Product Change Notification

Change Notification #: 112322 - 00
Change Title: Intel® Workstation System P4304CR2LFGN
PCN 112322-00, Product Design
Update Printed Board Assembly,
BIOS/ME/BMC/FRUSDR Firmware,
GP/GPU Cable and Quick Reference Guide
Date of Publication: May 31, 2013

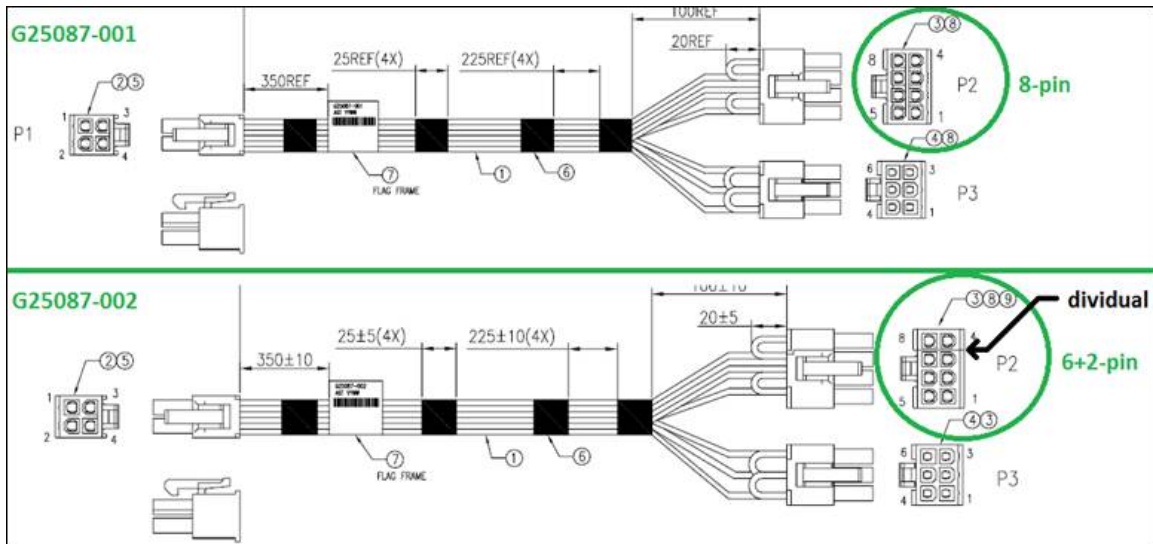
1. The GP/GPU power cable will be updated from G25087-001 to G25087-002, please refer to below picture for the detailed change.
